Works Approval Number	W5709/2014/1
Works Approval Holder	B. & J. Catalano Pty Ltd
ACN	008 961 975
Registered business address	2 South Western Highway BRUNSWICK JUNCTION WA 6224
Date of amendment	23 December 2016
Prescribed Premises	Category 12 – Screening, etc. of material: premises (other than premises within category 5 or 8) on which material extracted from the ground is screened, washed, crushed, ground, milled, sized or otherwise separated.
Premises	Shenton Ridge Gravel Quarry Coalfields Road ROELANDS WA 6226 Being Part Lot 501 on Plan 26892 and Lot 21 on Plan 10674, as depicted in Schedule 1

Amendment

Amendment Notice

Works Approval W5709/2014/1 was granted by DER on 31 March 2016 to allow works for the construction of additional gravel quarries at the Shenton Ridge Gravel Quarry.

Map of Air Quality Monitoring Infrastructure

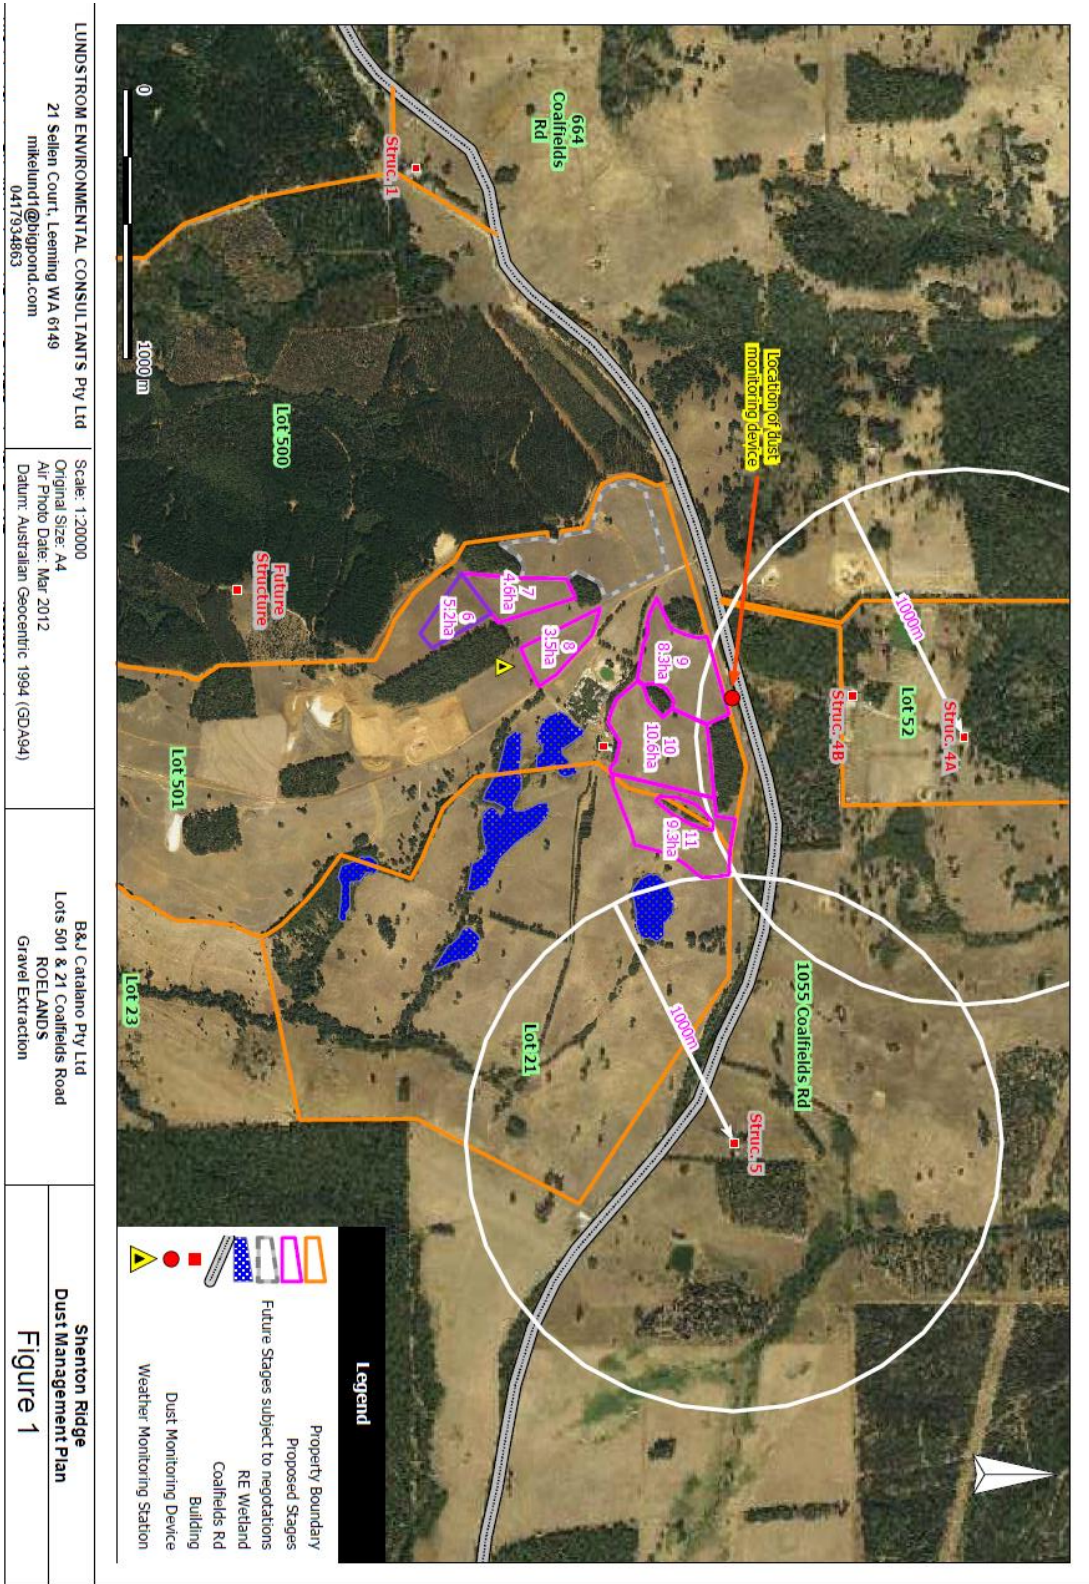
- Schedule 1 is amended by the insertion of the following maps and red text shown in underline below:

Map of Surface Water Catchment Areas, Site Topography and Surface Water Quality Monitoring

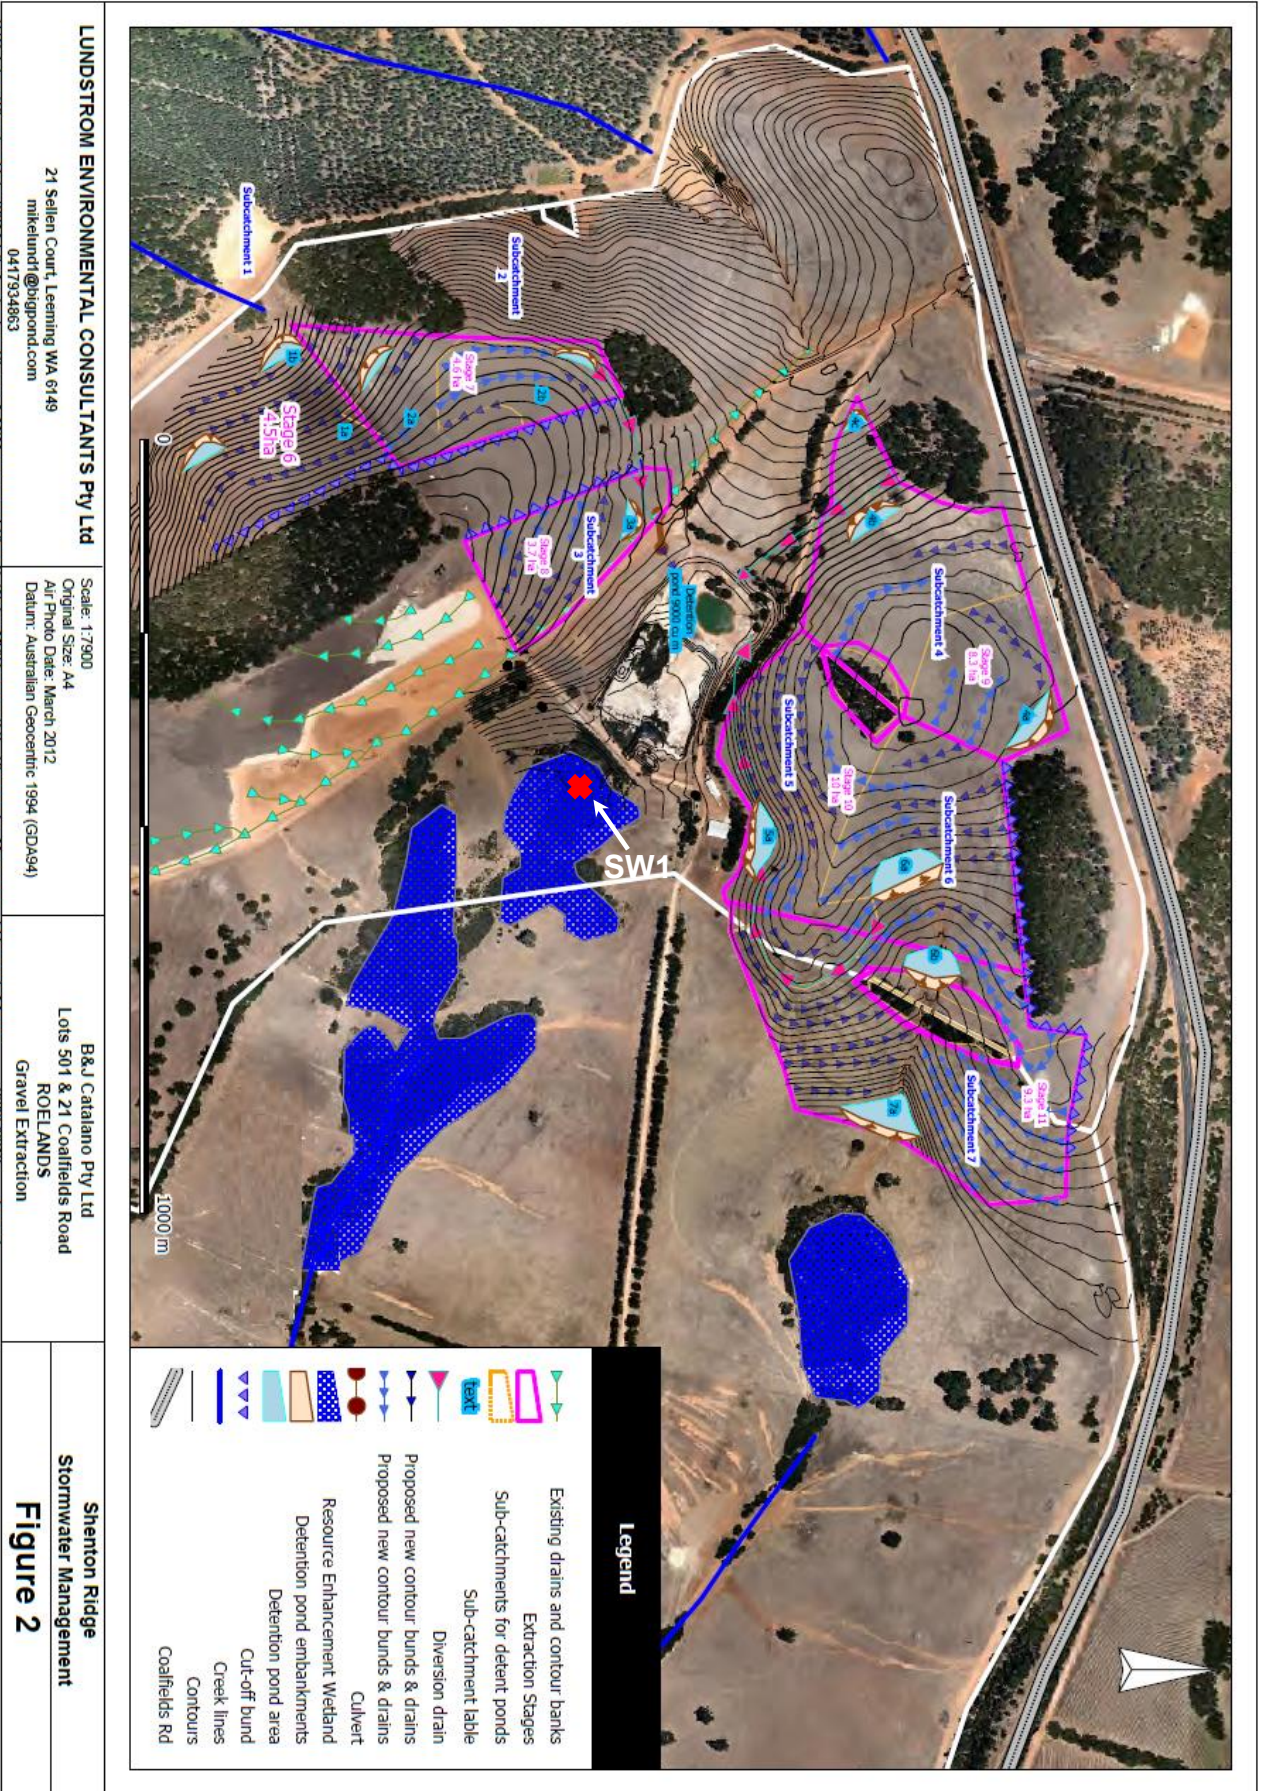
"DER's re-assessment was appropriate and that the Works Approval should be amended to include, a map indicating locations of stormwater management infrastructure, description of containment infrastructure components including detention basins, diversion drains, contour bunds and cut-off bunds, and a schedule defining the minimum storage capacity of individual detention ponds."

Infrastructure specifications and maps have been added by DER to the amended Works Approval in accordance with the Minister's decision.

~~Map of Surface Water Systems~~

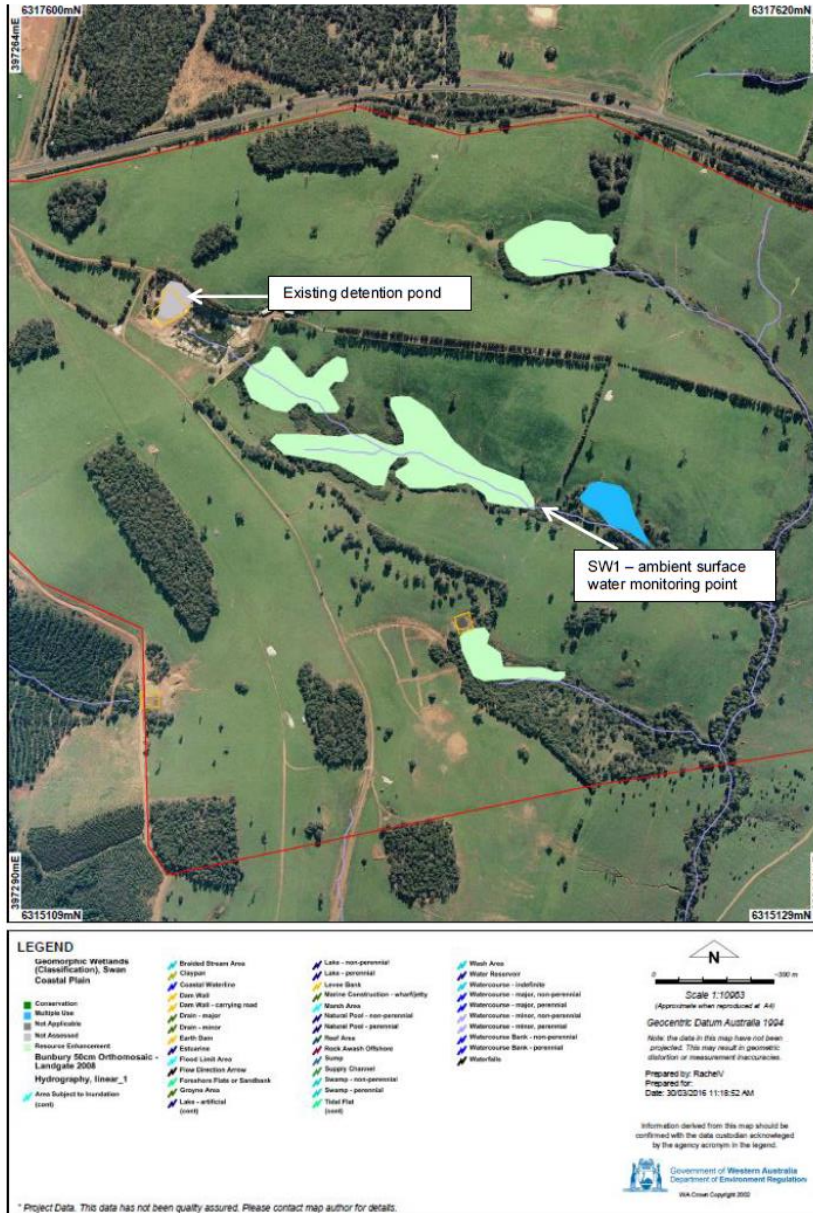
~~The surface water systems and existing detention pond are shown in the map below.~~
